NEW ORLEANS HISTORIC DISTRICT LANDMARKS COMMISSION
CENTRAL BUSINESS DISTRICT HISTORIC DISTRICT LANDMARKS COMMISSION

Re: 1510 Religious Street

Permit Number: 26-08766-HDLC

Description: Applicant is requesting retention of multiple deteriorated items and MEP systems at a Landmark, commercial building, work done without a Certificate of Appropriateness.

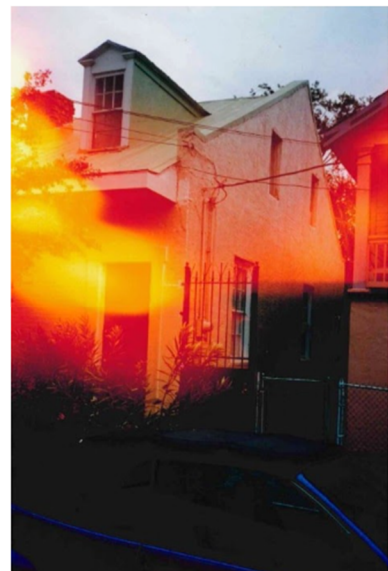
Deteriorated Masonry and Stucco:

The applicant is requesting the retention of the current condition of the masonry and stucco citing the want to keep the "historic" look of the deterioration. However, the HDLC Guidelines do not allow for maintaining the appearance of delaminated stucco. Further, the brick at this building is soft "lake" brick and shows signs of delamination and missing mortar joints. While staff appreciates the aesthetic concern of the applicant, the main interest of the HDLC in this matter is the level of deterioration of the masonry.

Unfortunately, this look of deterioration has long been romantically associated with a quaint New Orleans mystique that is understandably appealing to many. However, in reality, it is the result of moisture intrusion and indicates masonry deterioration. If left unaddressed, this can lead to failure of the material which is why this is referred to as “demolition by neglect”, as can be indicated in several recent partial building collapses. Best practice, would be to repoint all of the

failing and missing mortar joints and have a new coat of an HDLC approved stucco applied to all elevations. Further, photos from the 1990s into the early 2000s show the building completely encapsulated with stucco. Staff recommends denial of the retention to maintain the current level of deterioration of the masonry and stucco and recommends that the mortar be repointed and the delaminated stucco repaired.
